IN THE MATTER of Private Plan Change 28 – Maitahi Bayview

**EVIDENCE OF DALI SULJIC FOR SAVE THE MAITAI INC
STORMWATER
DATED 27 JUNE 2022**

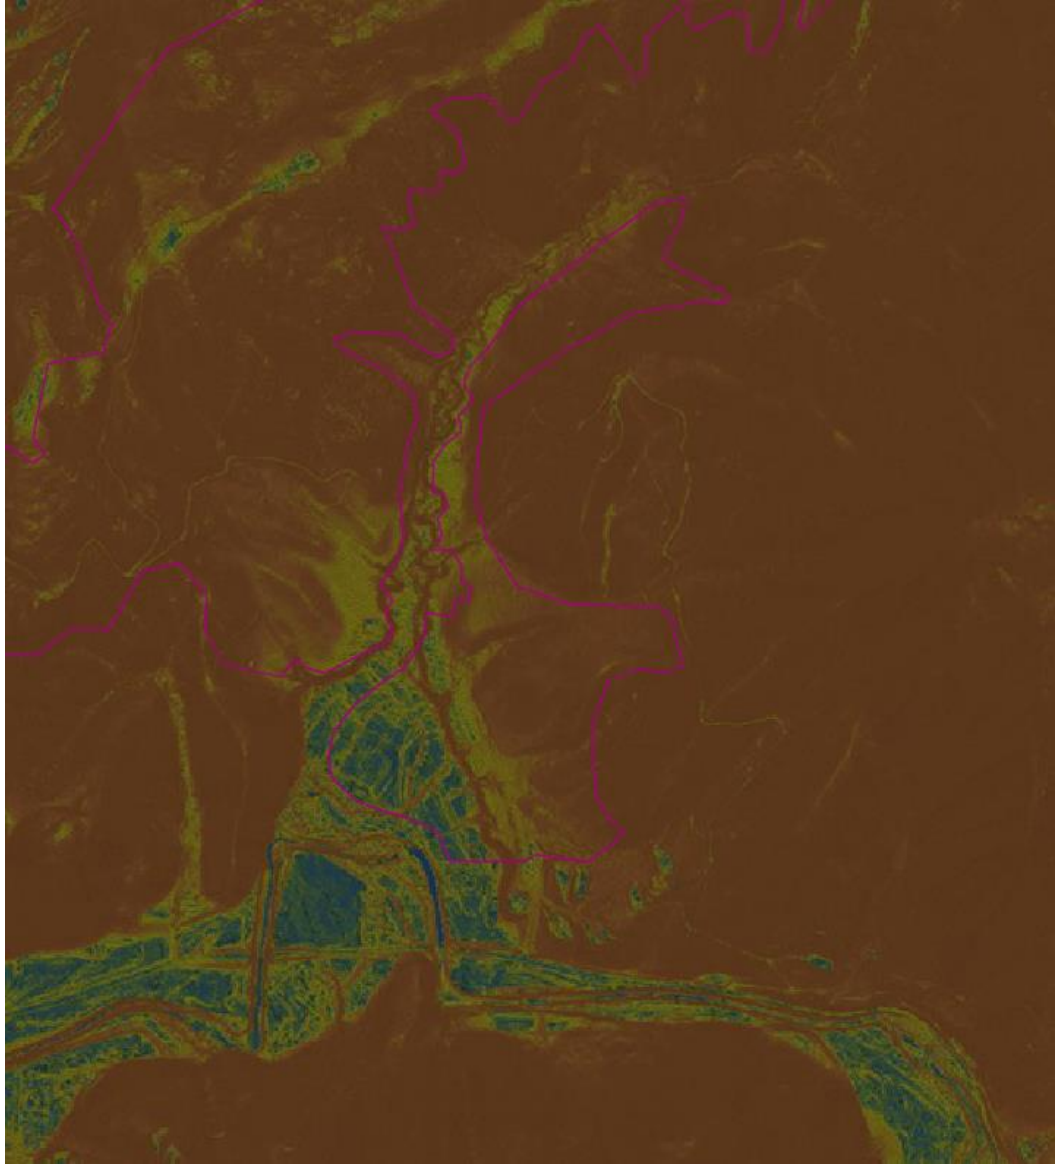
57. I have carried out a slope assessment using the available LiDAR data from the Nelson and Tasman region captured between 2008 and 2015. Figure 2 below shows the produced slope map including Kākā Valley with gradients exceeding 1-in-5 (20%) in brown. I have overlaid the approximate extents of the proposed residential/commercial zoning under PPC28 to highlight the proportionality of future development in the steeper areas. NTLDM limits the maximum longitudinal gradients for different orders of roads. Local Roads and Residential lanes are limited to 1-in-7 (14.3%) and 1-in-6 (16.7%) respectively. Relative to the proposed density, it is likely that relatively high levels of earthworks and retaining (in tandem with potential geotechnical stability measures), will need to be carried out to support PPC28 for a large proportion of the proposed development. This can significantly change the hydrology and affect the existing hydrological features. A further associated concern is the potential for bulk earthworks consents to be applied for independently of ultimate land use consents, which has the effect of predetermining the feasibility of stormwater management approaches and can preclude the implementation of best practice WSD. In my view, the SMP does not broadly recognise the topography constraints and has failed to demonstrate that the actual and potential effects of earthworks on hydrology can be managed through the proposed regulatory and design requirements.

58. Furthermore, the SMP proposes a stormwater management approach that utilises at-source green infrastructure. These include bioretention devices, raingardens, tree pits, vegetated swales, and wetlands. The implementation of these devices is closely linked to topography, particularly for the roadside applications, where successful implementation is generally limited to a longitudinal gradient of 1-in-

12.5 (8%). In my view, linking back to the topography challenges within the PPC28 area, the SMP has failed to demonstrate how the proposed green infrastructure devices can be practically implemented through the resource consent stages.
